McGREGOR SQUARE SUBDIVISION, RESUBDIVISION OF AND ADDITION TO LOT 1

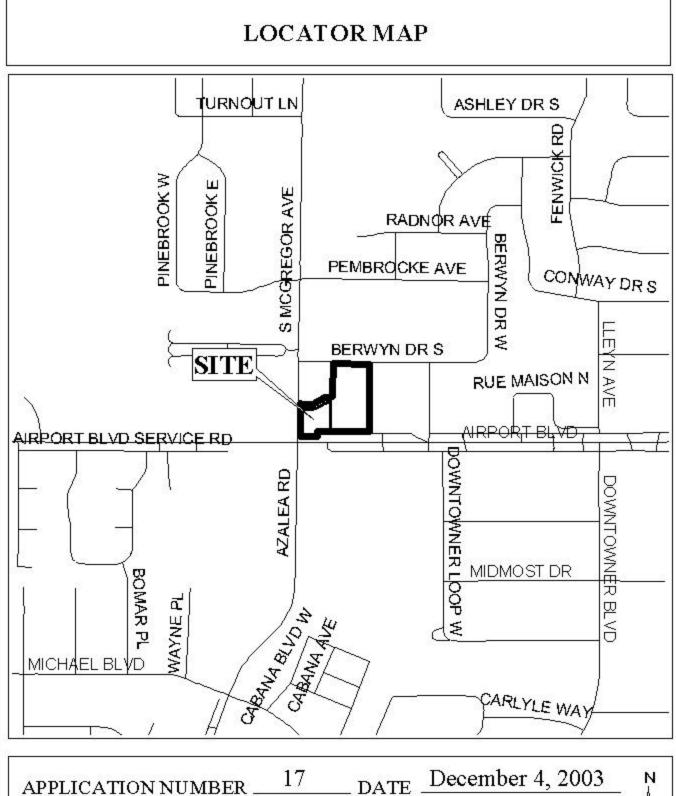
<u>Engineering Comments:</u> Must comply with all stormwater and flood control ordinances. Any work performed in the right-of-way will require a right-of-way permit.

<u>Traffic Engineering Comments:</u> Driveway numbers, size, location and design to be approved by Traffic Engineering and conform to AASHTO standards.

The site fronts Airport Boulevard and McGregor Avenue, both planned major streets, which have existing rights-of-ways of 100 feet and 60 feet; respectively. Additionally, as a method of access management, the number, location and design of all curb cuts should be approved by Traffic Engineering.

The plat meets the minimum requirements of the Subdivision Regulations and is recommended for Tentative Approval subject to the following condition: 1) the placement of a note on the final plat stating that the number, location and design of all curb cuts should be approved by Traffic Engineering.
